**Attachment 3: Responses to NRC RAIs Specific to WCAP-17788, Volume 1
Supporting the Closure of GSI-191 (PA-SEE-1090) and Mark-ups to
WCAP-17788, Volume 1 NON-PROPRIETARY Attachment**

NRC Correspondence, "Request for Additional Information RE: Pressurized Water Reactor Owners Group Topical Report WCAP-17788, 'Comprehensive Analysis and Test Program for GSI-191 Closure,'" August 2016, ADAMS Accession No. ML16102A357.

Figure RAI-3.6-1 Effect of Entrainment on Core Region Boric Acid Concentration

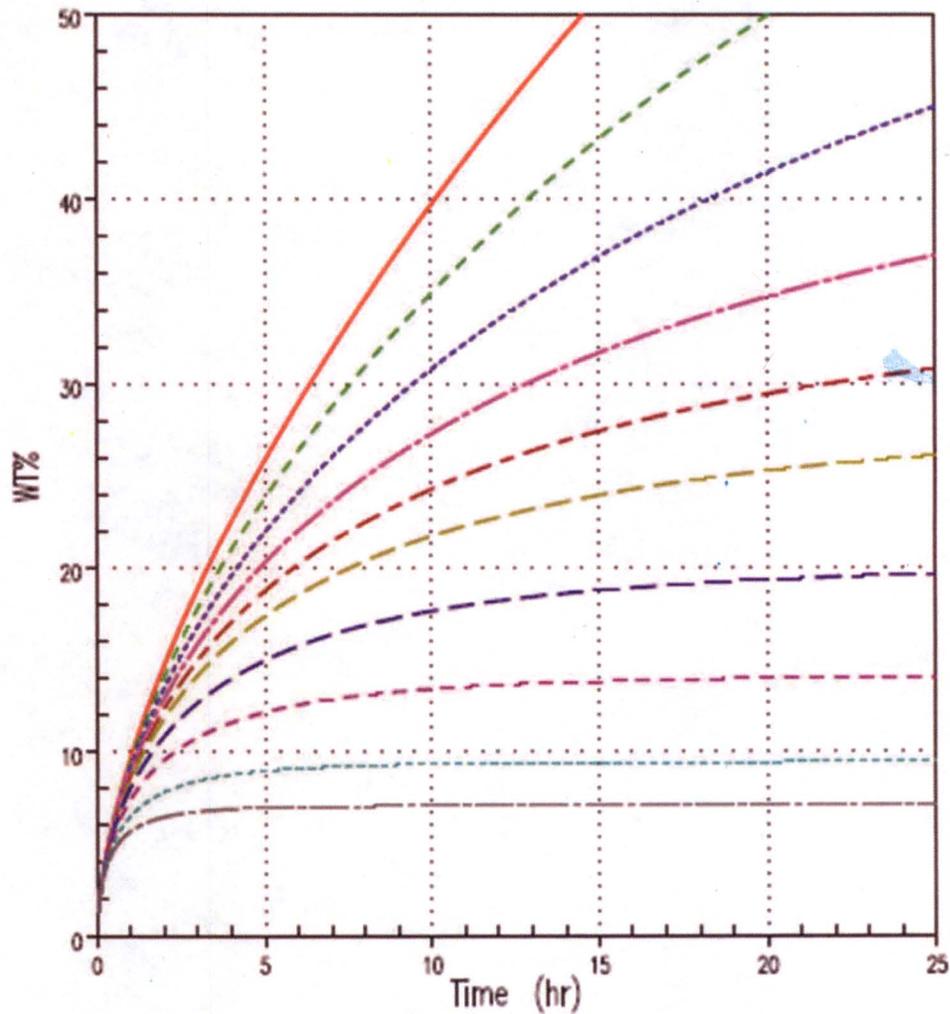
Section 7.1.1 of the supplement to Volume 1 states that the quality of the steam exiting the vessel remains low enough to limit the buildup of boron in the core. How was it determined that maintaining steam quality below 0.8 ensures carryover that will adequately limit the buildup of boron solutes in the core? What is the maximum allowable quality that will ensure excessive boron concentrations will not occur? Provide the basis for this value.

Starting with Case 1, a series of SKBOR runs were made with various levels of constant entrainment throughout the transient. For these cases, the boiloff makeup was assumed to be at a boron concentration of 2500 ppm (actual sump boron concentrations would be much lower). Table RAI-3.6-1 and Figure RAI-3.6-1 show the results of these runs. The results show that 95% RV exit steam quality (5% entrainment) will limit the core region's boric acid concentration to a level below the boric acid solubility

limit of 29.27 wt% at 14.7 psia. As expected, the SKBOR results closely match theoretical limit calculated by the above equations.

Results from this sensitivity study justify the statement made in Section 7.1.1 of the supplement to Volume 1 that the quality of the steam exiting the vessel remains low enough to limit the buildup of boron in the core, because it is shown that a steam quality of 80% results in a maximum theoretical boron solute concentration build-up of less than 7.2 wt% (Case 10, Table RAI-3.6-1). Steam qualities below 80% will result in a lower concentration build-up. The maximum allowable quality that will ensure excessive boron concentrations will not occur is approximately 95% (Case 6, Table RAI-3.6-1) for a boric acid solubility limit of 29.27 wt% at 14.7 psia.

Figure RAI-3.29-1 Error in Brine Test Inlet Flow Rate from Test T029

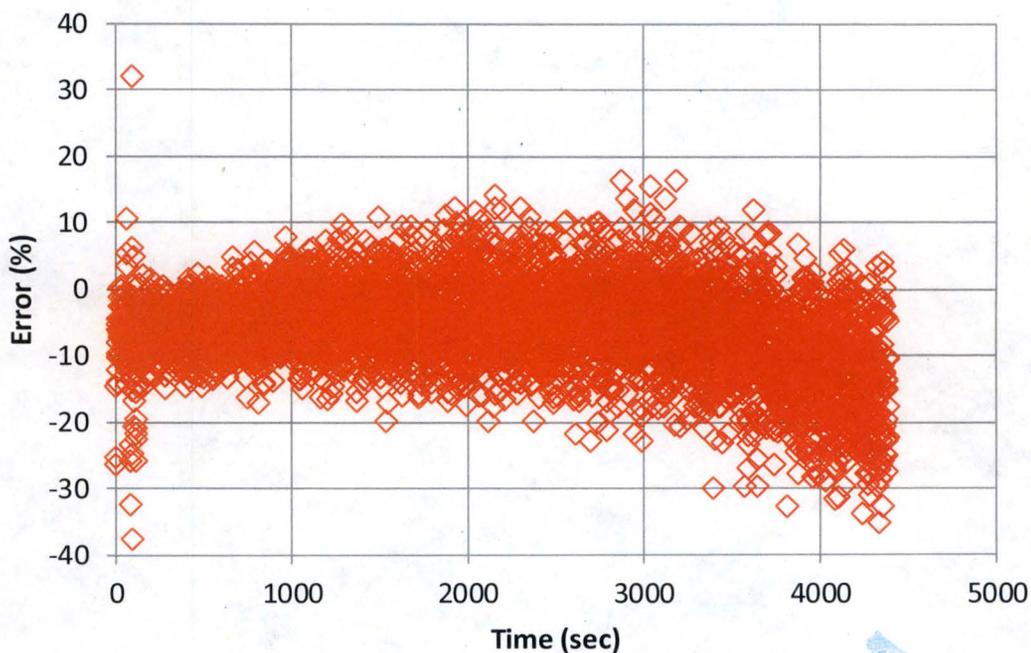
- a. Clarify whether the accuracy of the magnetic flow meter provided in Table 5-4 as "0.258% rate" is valid for the entire specified range from 0 to 100 gpm or it is based on the upper range limit of 100 gpm.
- b. Provide the accuracy for the brine injection flow rate relative to setting the speed of the positive displacement pump in order "to achieve the prescribed brine injection flow rate of 0.5 gpm."
- c. Provide the calculation for the error in the main flow rate used in the tests. Justify the applied main flow rates taking into consideration the applicable measurement error. Taking into consideration that "for all brine testing, the primary flow rate was set ... to follow a predetermined flow rate curve based on decay heat," the justification should substantiate the applicability of the test results on the basis of adequate representation of DH and its uncertainty.

Where Q_{test} is the calculated inlet flow rate from the test, and Q_P is the predetermined flow curve based on decay heat. The error is calculated for brine test T029. The measured outlet flow rate, brine injection flow rate, and calculated inlet flow rate from this test are shown in Figure 7-8 of PWROG-15091-P. The predetermined flow curve for this test is Flow Control 2 shown in Figure 5-5 of PWROG-15091-P. The uncertainty associated with the inlet flow rate (± 0.006 gpm) is not included in the error calculation since it is small compared to the inlet flow rate. Figure RAI-3.29-1 shows the error between the test inlet flow rate and the predetermined flow curve used in the testing for brine test T029. As the figure shows, the majority of inlet flow data points fall within a range of +20% and -30% of the predetermined flow curve.

Although the error between the calculated inlet flow rate from the brine testing and the predetermined flow curve is not negligible, it is acceptable. As described in the response to RAI-3.28, the brine testing determined the conditions under which a continuous debris bed could not form at the core inlet and represented those conditions in the form of Froude number. In determining the Froude number, the inlet velocity was taken from the test data, and not the

predetermined flow curve. As shown above, the uncertainty associated with the test inlet flow rate is very small (<0.006 gpm) such that the uncertainty in the velocity is small. For example, for an inlet flow rate of 0.8 gpm, the velocity through the Westinghouse bottom nozzle used in the brine testing is 0.0619 ± 0.0005 ft/s. The predetermined flow curve based on Appendix K decay heat was used to establish the range of inlet flow rates that was representative of the prototypic large cold leg break scenario, but since the condition under which a continuous debris bed cannot form was determined from the test data, it was not required that the flow rate used in the testing followed the predetermined flow curve with great accuracy.

Figure RAI-30.3-1 Subscale Test Facility Control Volume for Brine Testing

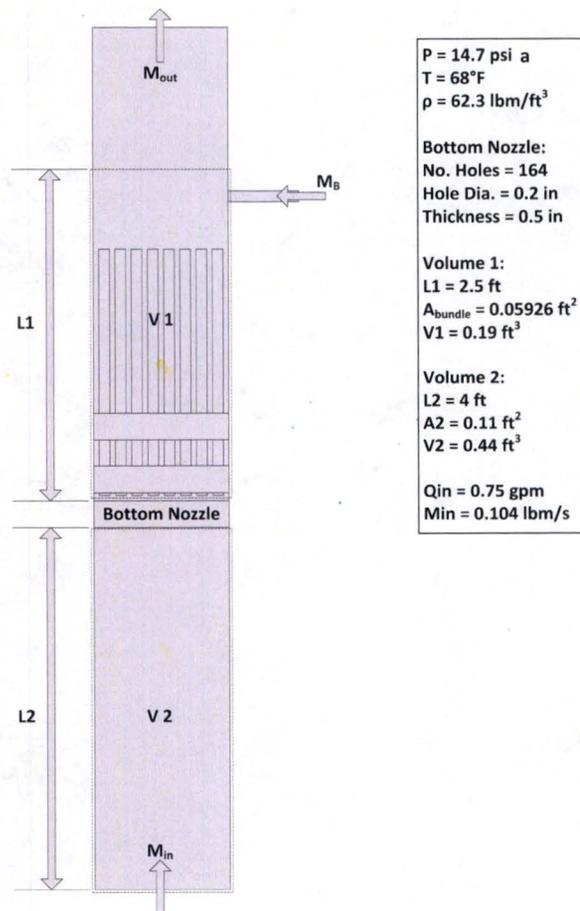
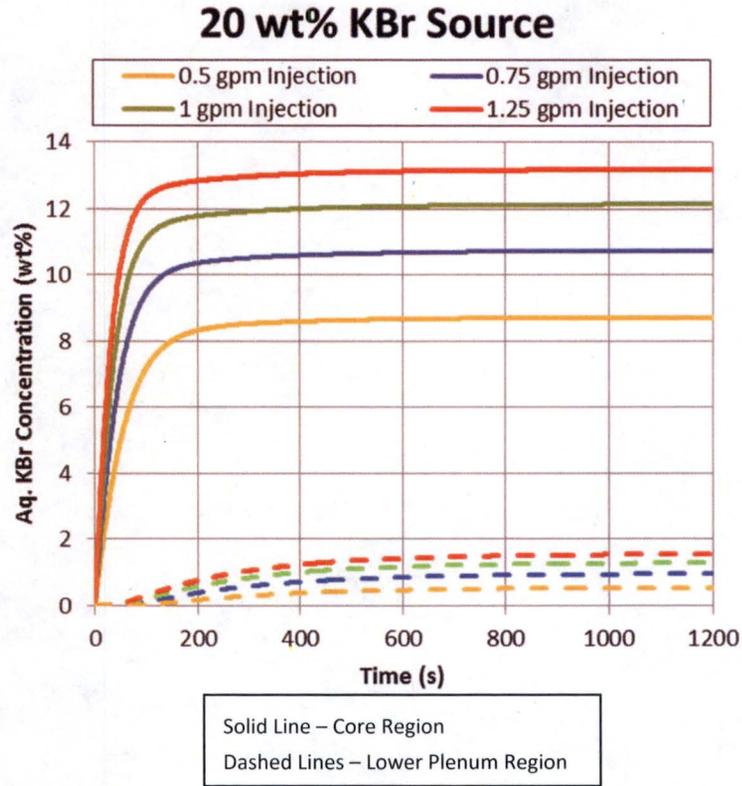
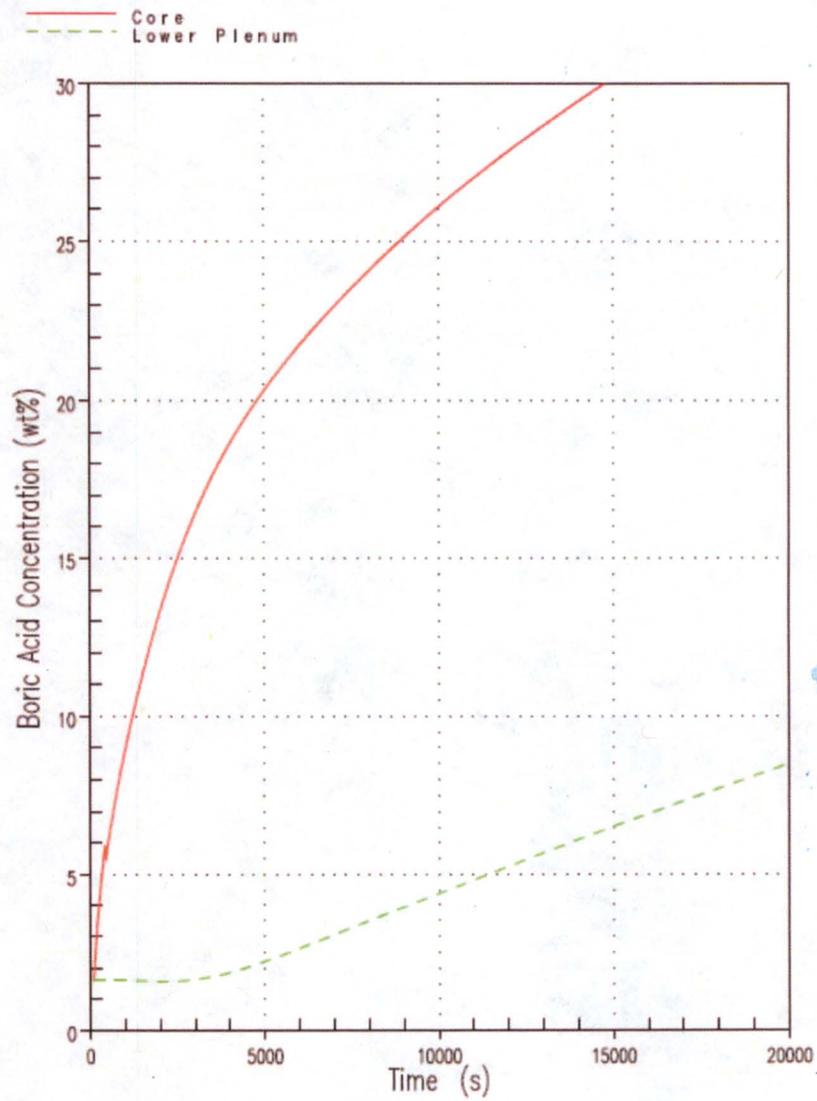
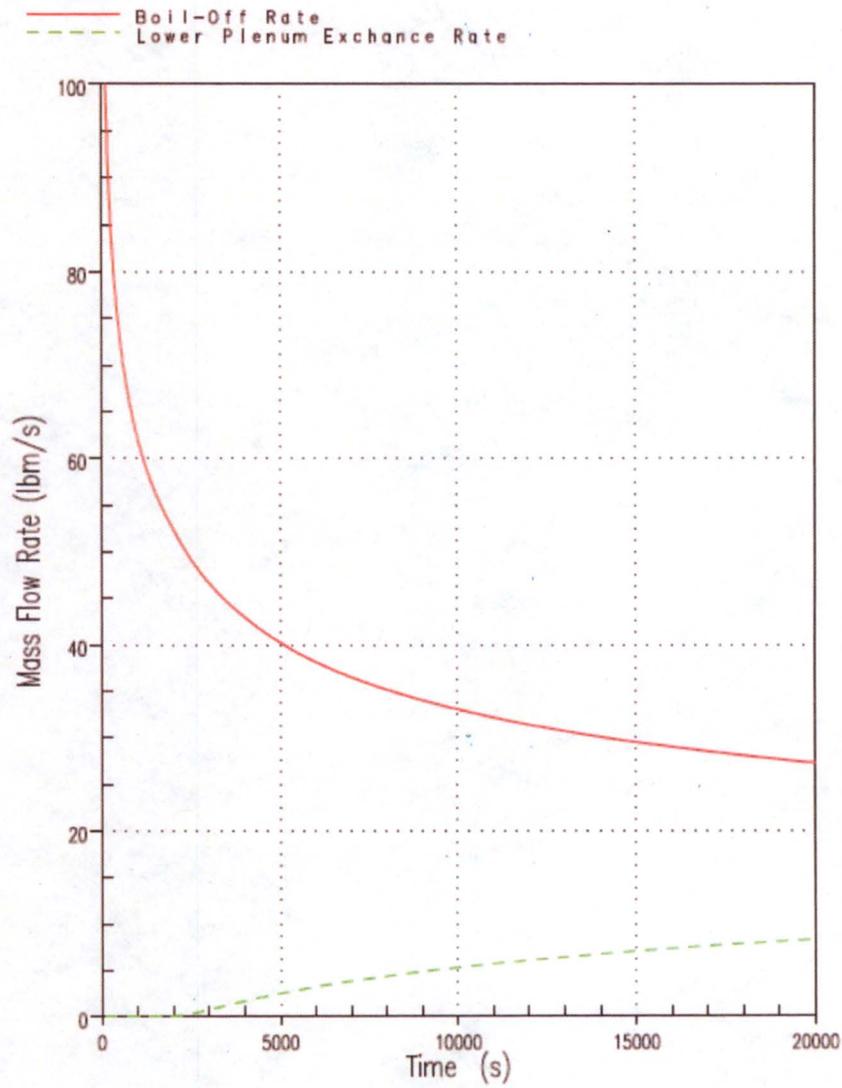
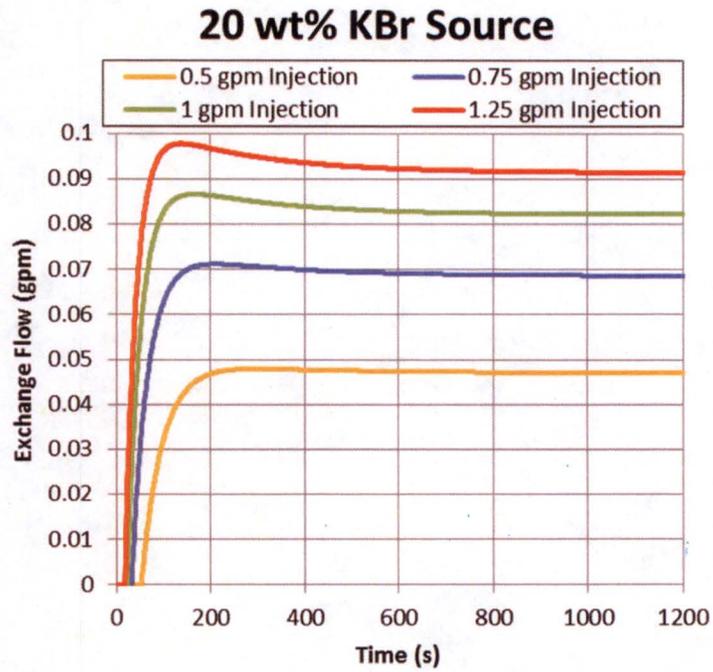
The scalability of the tests with regard to time is in question. The relation between the timing in the tests and the timing of the process of solute accumulation in the prototype system is not established in the test report. It is not clear how the real time scale can be transposed relative to the experimental time scale at each source concentration level used in the tests. Provide the scaling basis for the applied process of brine solute injection in the tests so that the relevance of the timing aspect of the observed processes can be related to the behavior of the prototype system.

The design of the subscale facility makes it impossible to scale the tests with regard to time. Instead of simulating a transient condition in which the solute concentration in the core region is continually increasing, the strategy taken for the brine testing is to create a series of steady-state conditions in which buoyancy driven exchange flow will occur in the subscale facility. Figure RAI-3.30-1 shows the control volume defined for the test scenario. As the figure shows, brine will be injected into control volume 1 (V1) several inches above the test section geometry. As the brine concentration builds within V1 a density gradient will develop between V1 and control volume 2 (V2). Once the density gradient is large enough to overcome the upward flow through the flow column, buoyancy driven mass transport will begin.

Prior to starting the brine testing, simulations were performed to help define appropriate boundary and initial conditions for the testing. Applying the transport model discussed in Section 3.3 of PWROG-15091-P to the subscale system shown in Figure RAI-3.30-1, the concentration buildup and exchange flow can be estimated for various brine injection flow rates and concentrations. Figure RAI-3.30-2 shows the predicted concentration buildup in the subscale flow column using a fixed source injection concentration of 20 wt% KBr. Note, a source concentration of 20 wt% KBr was not used in the testing because it was determined that the equivalent boric acid concentration would be near the solubility limit. However, the conclusions drawn from the subscale system analysis discussed here would not change based on the value of the source concentration chosen. Figure RAI-3.30-2 shows the onset of mass transport occurs much earlier compared to the prototypic system prediction shown in Figure RAI-3.30-3. The prototypic system predicts the onset at half an hour while the subscale prediction is before 100 seconds for the four injection flow rates analyzed.

time, concurrent with brine and debris injection, was chosen to represent a condition in which the onset of buoyancy driven convection had occurred consistent with the time of debris arrival. The second time, delayed brine injection, was chosen to represent a condition in which a debris bed had begun to form prior to the onset of buoyancy driven convection.

Figure RAI-3.30-4 shows the exchange flow transient from the prototypic system, predicted from the transport model. The exchange flow begins at zero and increases over time. At 4 hours the exchange flow through the core inlet is approximately 6 lbm/sec. Scaling this value to the subscale geometry results in an exchange flow rate of approximately 0.07 gpm. Figure RAI-3.30-5 shows the estimated exchange flow rate for the subscale geometry with a 20 wt% KBr source injection concentration and various injection flow rates. The figure shows that an injection flow of 0.75 gpm results in an exchange flow rate of approximately 0.07 gpm. Although the exchange flow rate is preserved, it is only for a given point in time for a specific plant condition. For these reasons the source concentrations were varied within the test matrix in order to create a range of exchange flow rates.

Figure RAI-3.31-1 Comparison of KBr Concentration below Core Inlet following Injection from the Two Sparger Orientations (Holes Pointing Down vs. Holes Pointing Up)

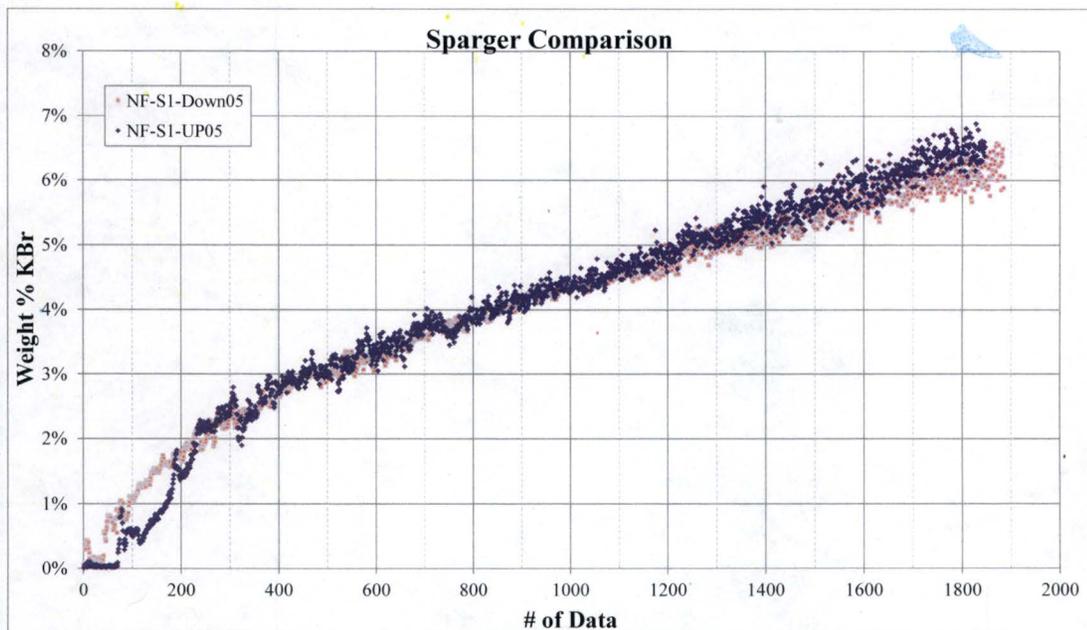
Section 5.3 in PWROG-15091 describes the sparger pipe used for injecting the brine solution into the test section. The resulting average fluid exit velocity at the applied brine injection rate of 0.5 gpm was 0.97 feet per second (ft/sec) (29.5 centimeters per second). Based on the sketch in Figure 5-14, the holes were located along the axial length of the sparger so that the flow velocity through the hole(s) farthest from the blocked end of the sparger should have been noticeably larger than the average injection velocity of 0.97 ft/sec.

Section 5.3 explains that a brine solution injection velocity of 1.94 ft/sec corresponding to an injection rate of 1 gpm "is sufficient to induce mixing in the subscale core region but is low enough to minimize any impact on the buoyancy-driven process being studied." Section 7.1, describing the pressure response observed in the tests, states in part that "the pressure trends seen throughout the test program include a small pressure spike corresponding to the start of brine injection..." Figure 7-2 shows the pressure record for Test T021 with delayed brine injection, which is described "typical" for all tests with delayed brine injection. The initiation of brine injection caused a significant jump of about 3 pounds per square inch (psi) gauge in the system pressure. Presumably, the measurement was taken from the upstream pressure transducer, shown in Figure 5-1, which had an accuracy of plus or minus 0.289 psi based on Table 5-4. A similar effect is also seen in Figure 7-1 for Test T029 with no brine injection delay.

Provide justification that jetting did not have an impact on the test results including the timing of the testing observations. Justify that the major findings from the tests relevant to WCAP-17788 are not affected.

Shakedown testing was performed for two different sparger hole sizes and orientations. The first sparger design utilized 6 holes all with a diameter of 3/16 inches. Upon testing this design it was observed that the brine distribution through the holes was not uniform. As a result, the hole diameters were adjusted to correct for this effect. The revised design utilized holes that progressively get smaller in 1/32 inch increments to create a more uniform brine injection. Visual inspection during shakedown testing confirmed that the brine injection is uniform across the flow area of the test section.

With regard to sparger orientation, two different orientations were considered. The first orientation had the sparger holes pointing downward while the second had the sparger holes pointing upward. Testing showed that regardless of orientation, the brine distribution and transport rates were comparable and independent of sparger design as shown in Figure RAI-3.31-1. Regardless of this outcome, the orientation with the sparger holes pointing upward was chosen to ensure that any inertia due to the injection will not influence the transport process at the core inlet or disrupt the debris bed.
